**From:** [Robeson Hannan, Lynn](#)  
**To:** [Johnson, Nana](#)  
**Cc:** [Berry, Nic](#)  
**Subject:** FW: CU 23-12, Brookstone  
**Date:** Friday, February 16, 2024 10:08:36 AM  
**Attachments:** [image001.png](#)  
[image002.png](#)  
[image003.png](#)  
[image004.png](#)  
[image005.png](#)  
[image007.png](#)

**From:** Robeson Hannan, Lynn <[Lynn.RobesonHannan@montgomerycountymd.gov](mailto:Lynn.RobesonHannan@montgomerycountymd.gov)>  
**Sent:** Wednesday, February 14, 2024 5:59 PM  
**To:** Beall, Mark <[Mark.Beall@montgomeryplanning.org](mailto:Mark.Beall@montgomeryplanning.org)>  
**Cc:** Butler, Patrick <[patrick.butler@montgomeryplanning.org](mailto:patrick.butler@montgomeryplanning.org)>; Soo Lee-Cho <[sleecho@bregmanlaw.com](mailto:sleecho@bregmanlaw.com)>  
**Subject:** CU 23-12, Brookstone

Exhibit 42 (a)  
OZAH Case No: CU 23-12

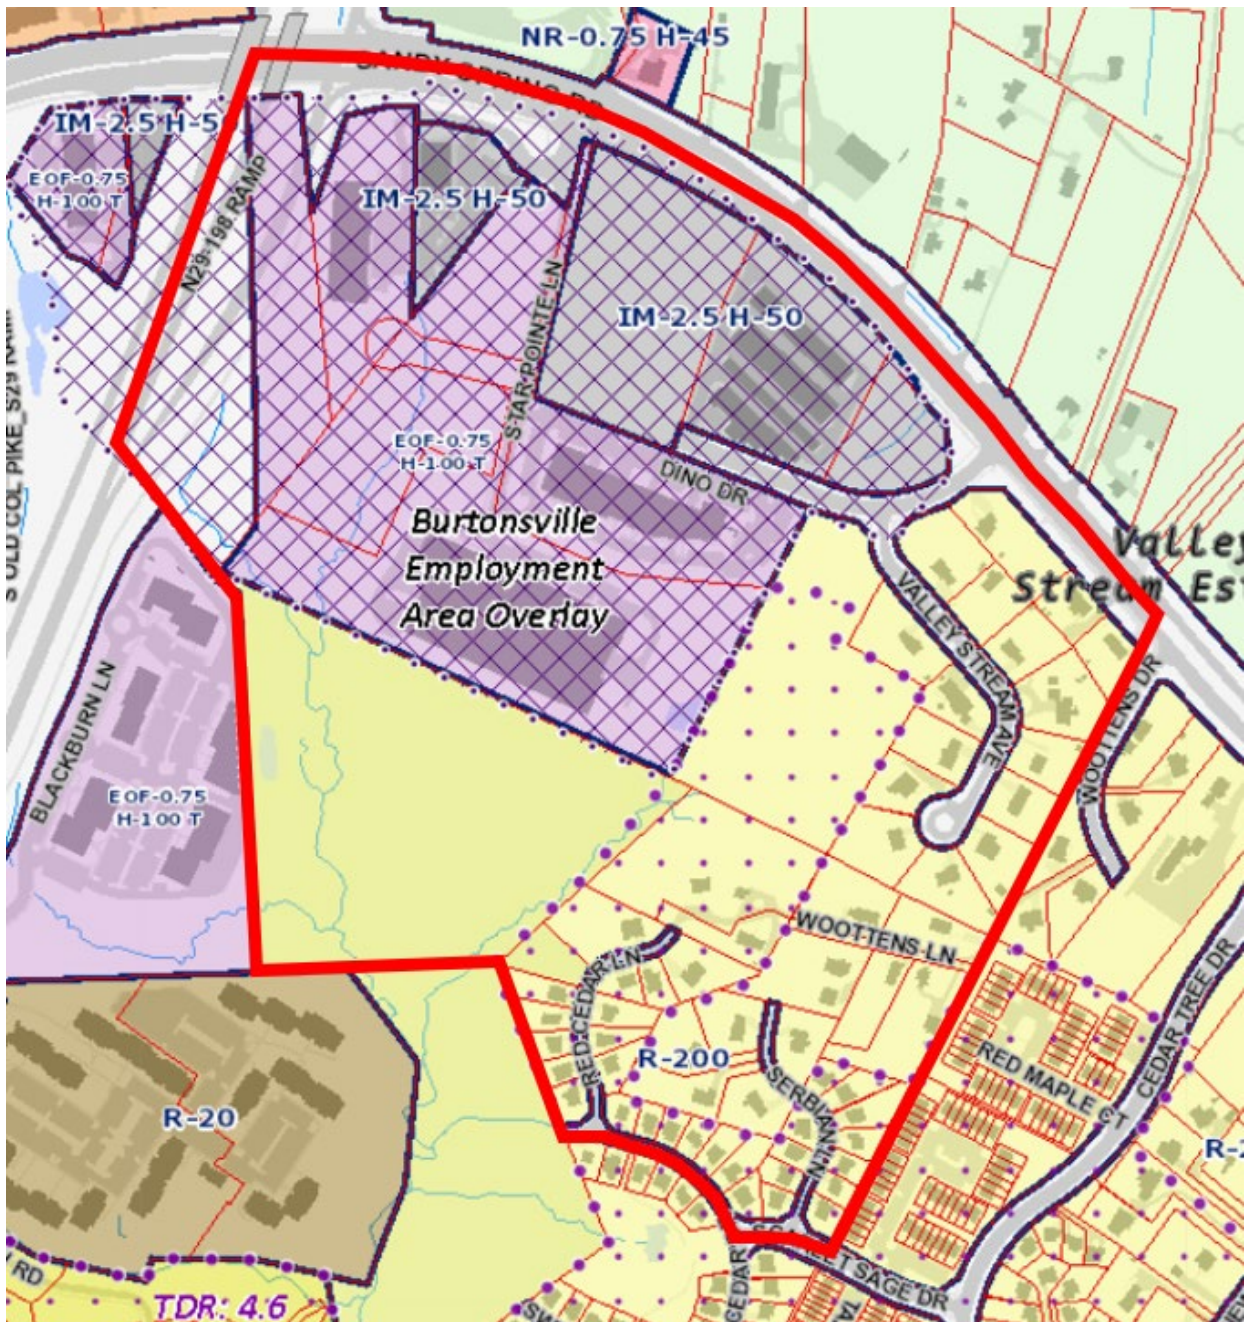
Can you spell out the boundaries of the surrounding area? I can't tell which roads they follow or what the jagged lines are (e.g., property lines??)

**The north boundary is Sandy Spring Road and then the east boundary goes from north to south along a series of property lines between the properties that front on Valley Stream Avenue and the properties/subdivisions that front on Cedar Tree Drive. The southern boundary line then runs from the eastern boundary along Scarlet Sage Drive to Red Cedar Drive and then runs behind the properties fronting on Red Cedar Lane. The southern line continues across between two parcels of the Fairland Rec Park westerly towards the office park fronting on Blackburn Lane and then continues along that rear property line to Route 29, Columbia Pike. The western lot line continues up Route 29 and ties into the previously mentioned northern boundary line.**
